Service Bulletin

Category 7	Applicable Model/s 1988-1989 626/MX-6 (Turbo)	Subject REVERSE IDLE GEAR MODIFICATION	Bulletin No. 057/89 Issued 9/27/89 Revised
---------------	---	---	--

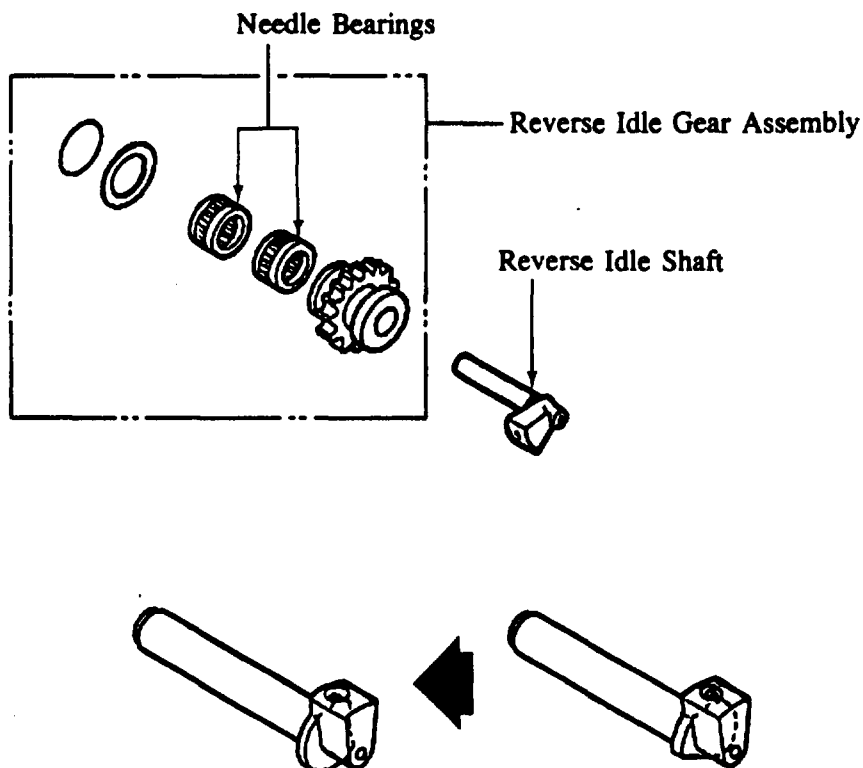
To improve the overall durability and operation of the reverse idle gear assembly, the following modifications have been introduced.

- 1) The needle bearing in reverse idle gear assembly has been improved.
- 2) The hardening process has been applied on the surface of reverse idle gear to which needle bearing touches.
- 3) The reverse idle shaft has been redesigned.

If complaints of erratic operation or excessive wear are found, please replace both the reverse idle gear assembly (including needle bearings) and reverse idle shaft with modified ones.
